Sheet: /
File: boitarire.kicad_sch

Title: Boite à rire

Rev: v1.2
Id: 1/1

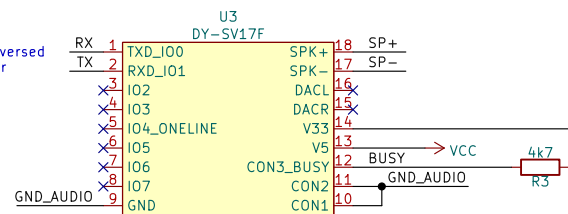
Issue#6 : RX and TX are reversed
between sender and receiver
